SAFETY EVALUATION BY THE OFFICE OF NUCLEAR REACTOR REGULATION

SUPPORTING AMENDMENT NO. 29 TO PROVISIONAL OPERATING LICENSE NO. DPR-45

LA CROSSE BOILING WATER REACTOR

DOCKET NO. 50-409

FIGURE 1

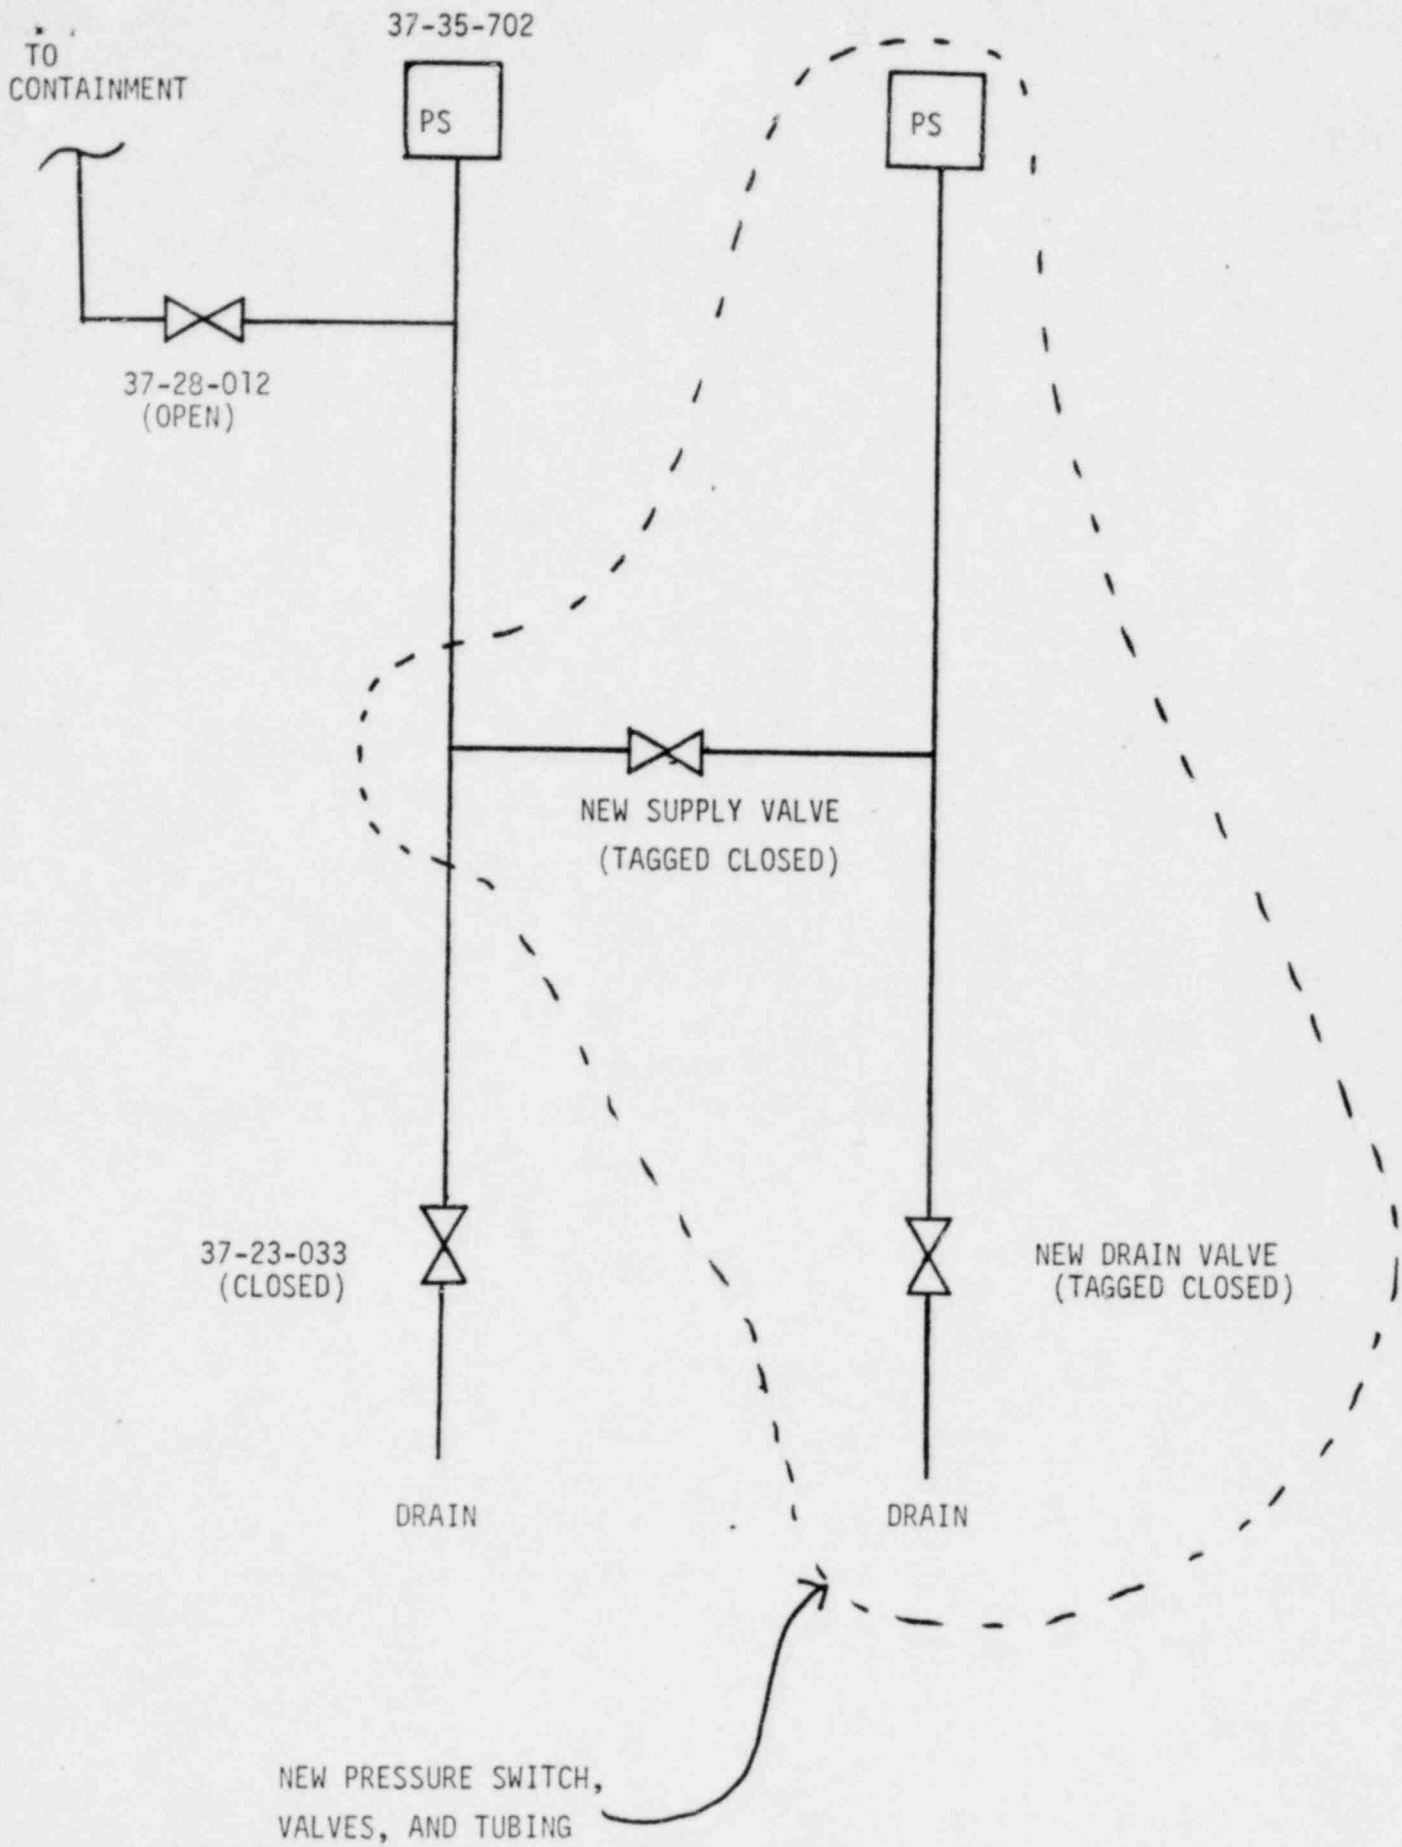
On May 17, 1981, a LACBWR Supervisor discovered a modification had been made to the Containment Building pressure sensing line leading to Pressure Switch 37-35-702 which activates 1B High Pressure Core Spray Pump (HPCS) and 1B High Pressure Service Water (HPSW) Alternate Core Spray (ACS) Pump and sends half the opening signal to the AC Alternate Core Spray Valve on high Containment Building pressure of 5 psig. The installation had been made without an approved Maintenance Request or Facility Change. The modification consisted of an additional pressure switch, two additional valves and 3/8 in. copper tubing (See Fig. 1). The modification had been assembled and leak tested at 60 psig without leakage prior to being installed.

During the installation on April 1, 1981, the valve between the containment wall and the Pressure Switch 37-35-702 had been closed for approximately one minute. If the Containment Building had become pressurized during this time, the 1B HPCS Pump, 1B HPSW/ACS Pump and AC ACS Valve would not have received a high pressure actuating signal. The 1A HPCS Pump, 1A HPSW/ACS Pump and DC ACS Valve and other starting signals, were unaffected by the installation. Therefore, the installation process reduced the degree of redundancy in these systems, but would not have prevented system actuation if required.

A leakage test was not performed after installation so that it could not be established that the fitting connecting the modification and the sensing line would not leak in excess of Technical Specification limits when internally exposed to 52 psig and that containment integrity existed. The licensee requested permission to shut valve 37-28-012 long enough (1) to test the new connections, in order to assure that containment integrity had been maintained, and (2) to remove the unauthorized modification and restore the system to its original configuration.

In his letter of May 19, 1981, the licensee included a copy of the proposed procedure to test the modification and restore the system. The procedure included the stationing of an additional operator to monitor reactor conditions during the evaluation and to be ready to activate the HPCS and ACS if they should be needed. The licensee estimated that the entire evolution would take about one hour to complete. Because the 1B HPCS pump and 1B HPSW pump continued to be manually operable, because a special operator for the HPCS and ACS would be stationed during the modification, and because the modification would take such a short time to complete, we determined that a temporary technical specification change was appropriate and acceptable. We, therefore, approved the following additional paragraph for Section 4.2.2.15 on May 19, 1981:

"Core spray pump 1B may be removed from service for up to one hour for maintenance of pressure switch 37-35-702. This provision shall be effective at 4:00 p.m. CDT May 19, 1981 and shall expire at 12:01 a.m. CDT on May 22, 1981."
